**DOCUMENT 00 90 00**  
**ADDENDUM**

**ADDENDUM No.:** 2

**RE:** HOUSING AUTHORITY OF THE CITY OF LA CROSSE  
2024 SMOKE ALARMS  
LA CROSSE, WISCONSIN 54601  
PROJECT NO. 24034

E201

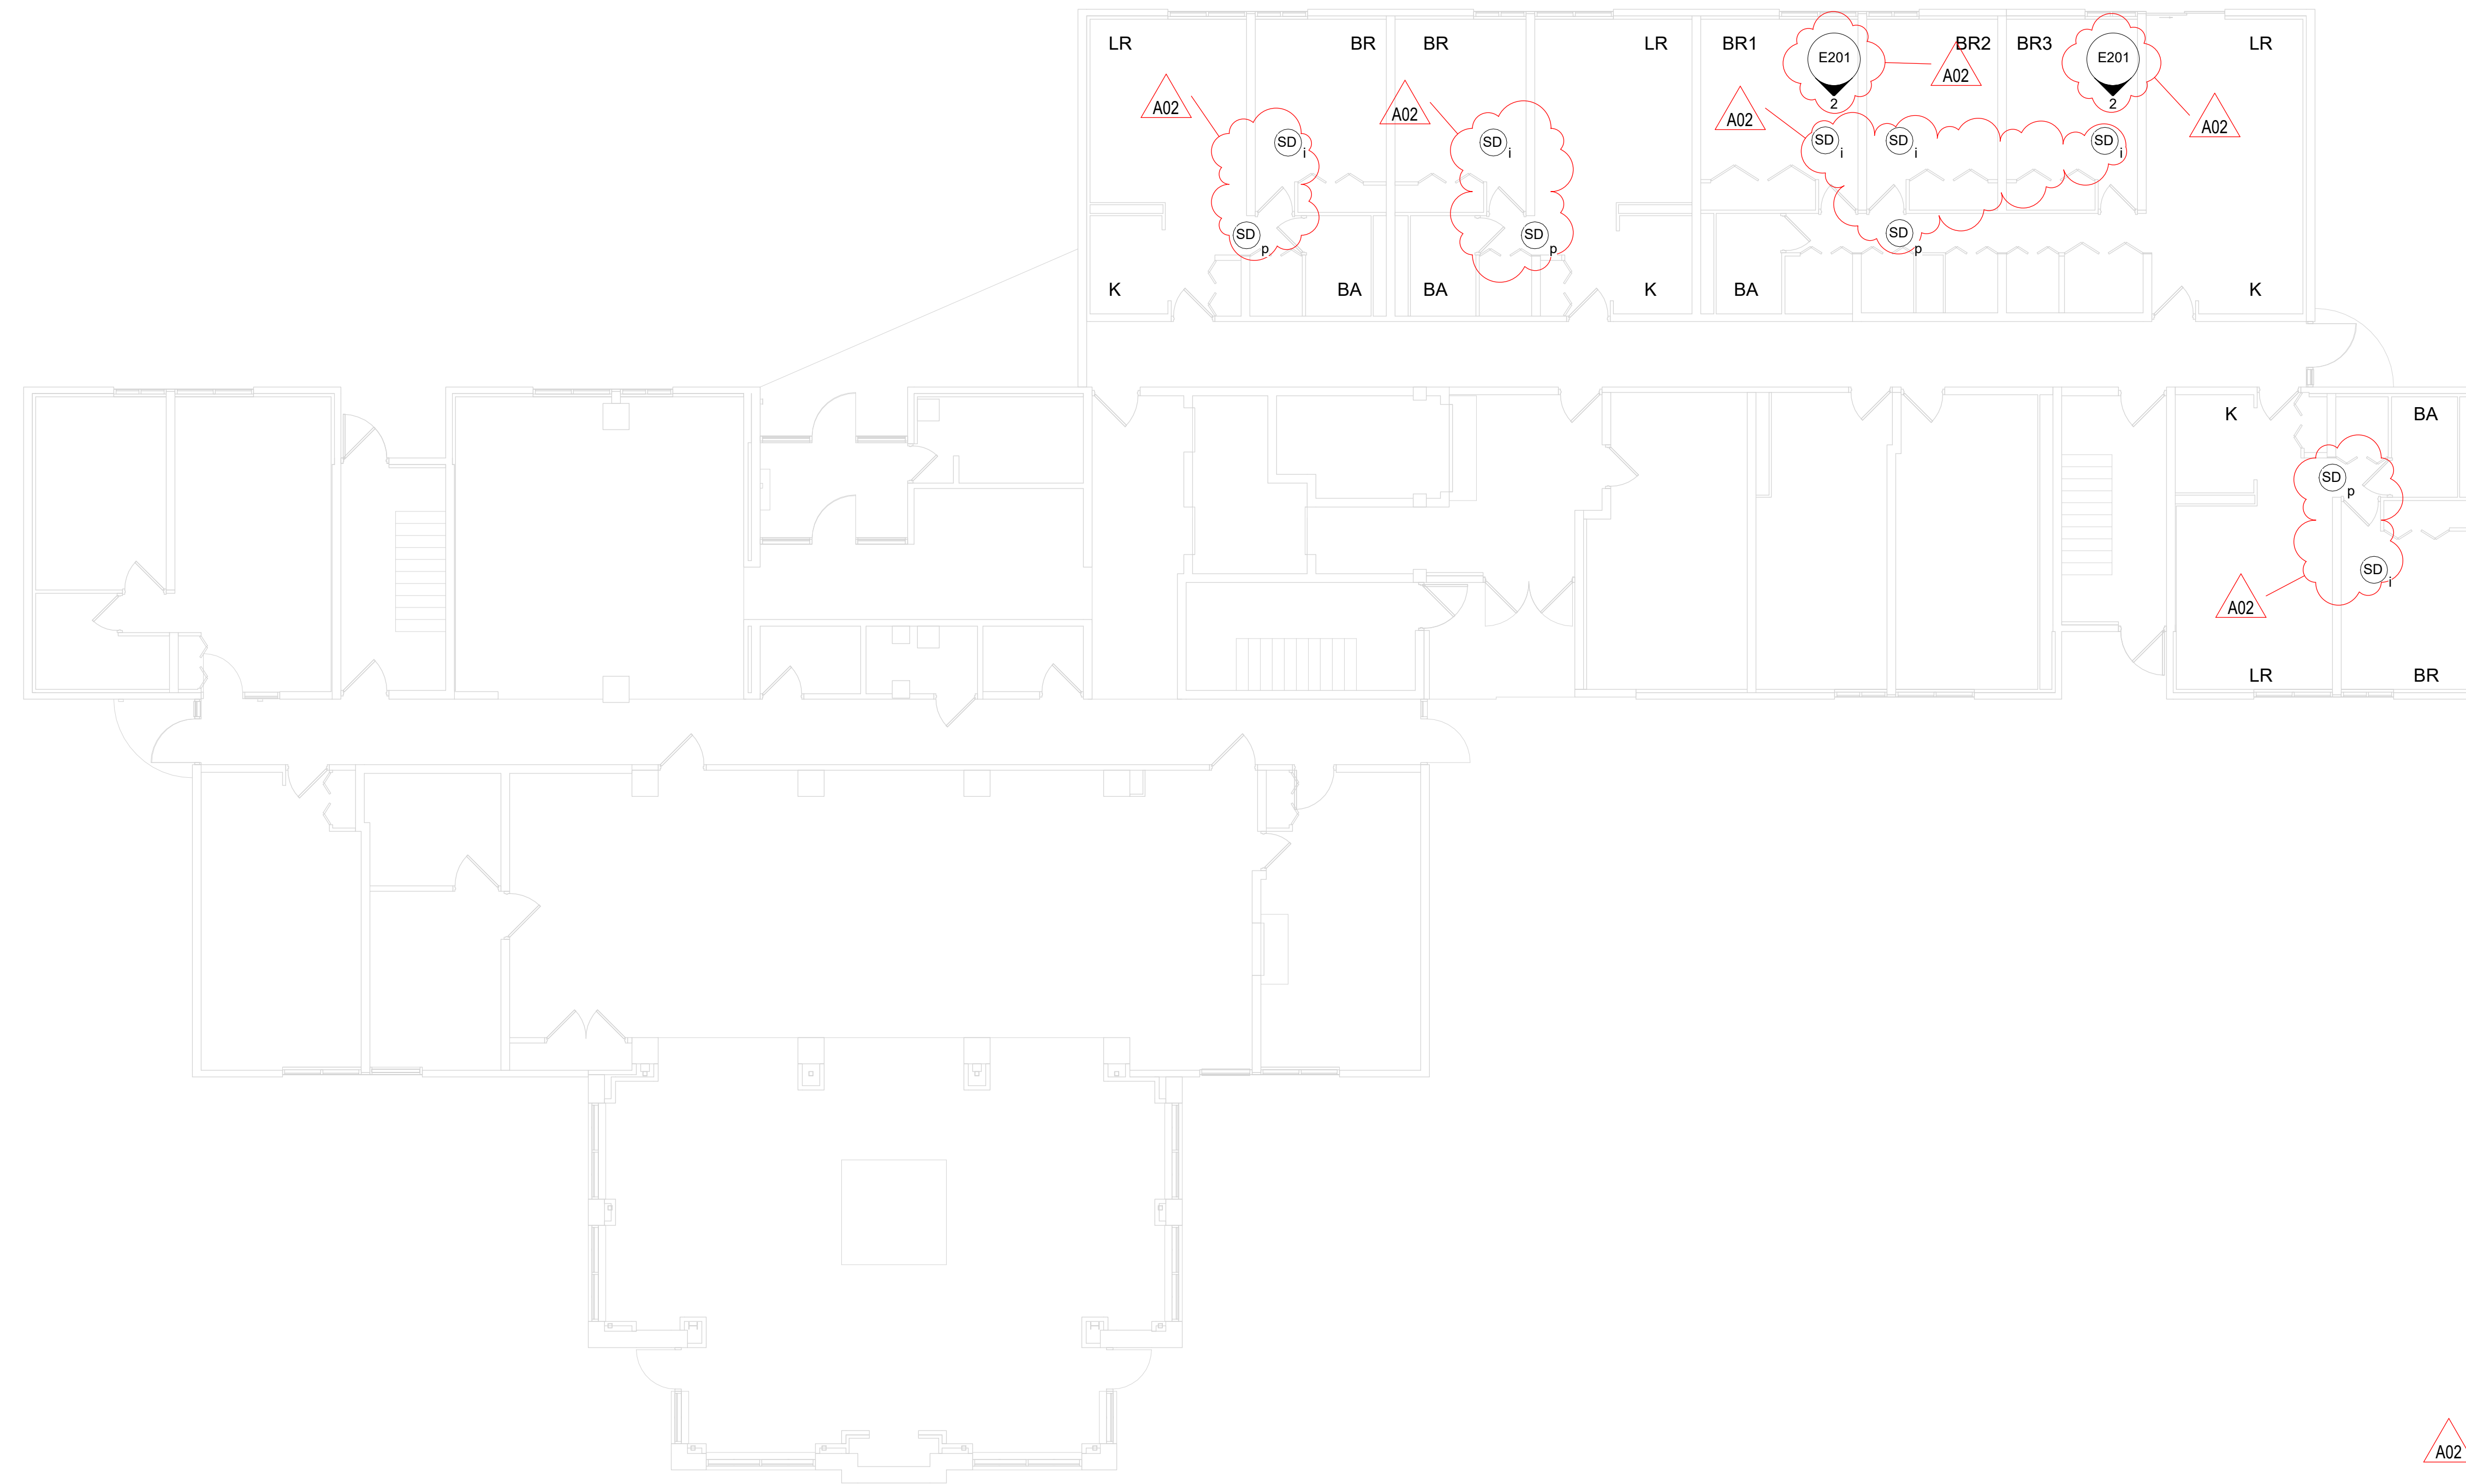
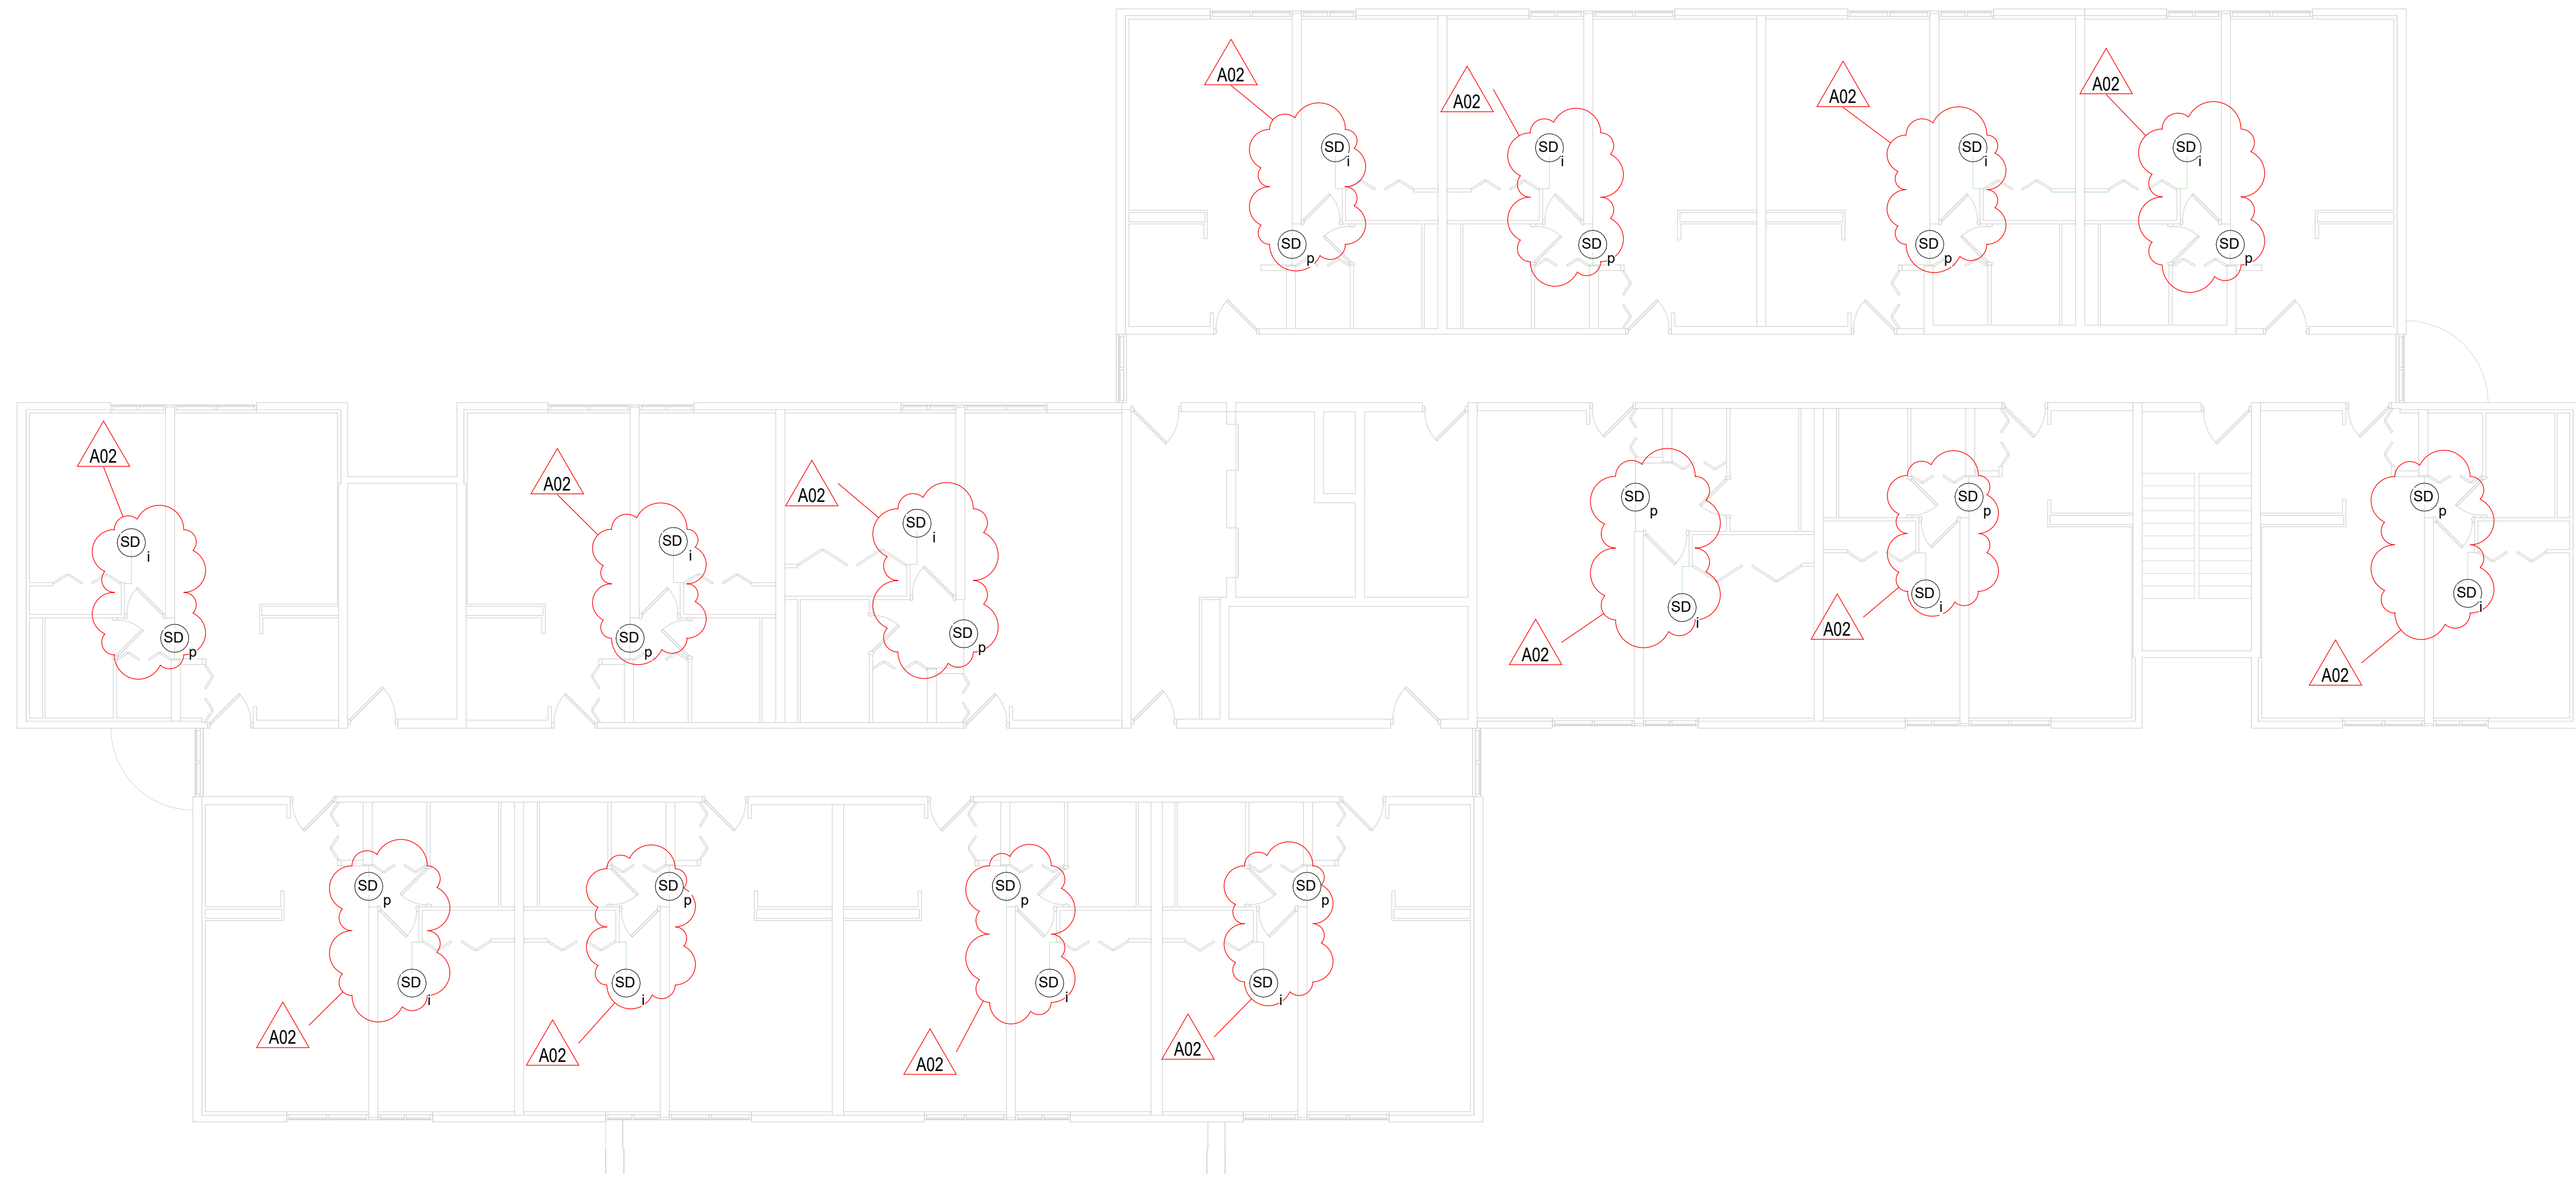
### 6. Sheet E201 SMOKE ALARM UNIT PLAN 30"x42"

- a. See the revised sheet included in this addendum. Disregard the previous version.
- b. Revised sheet to reflect a changed approach from wired smoke alarms to wireless. See clouded changes for requirements.
- c. Added notes regarding removal of existing equipment and smoke alarm selection in proximity to fuel-fired equipment.
- d. Revised clouded plan views to remove wiring and conduit.
- e. Added photo to show an example unit interior.

**IF REMOVING ANY HARDWIRED DEVICE WITHOUT INSTALLING NEW DEVICE ON JUNCTION BOX, CAP ALL WIRES AND ADD DECORATIVE BLANK COVER TO JUNCTION BOX TO COVER OPENING TO FINISHED SURFACE. BASIS OF DESIGN IS: ARLINGTON #CP3540, OR EQUAL.**
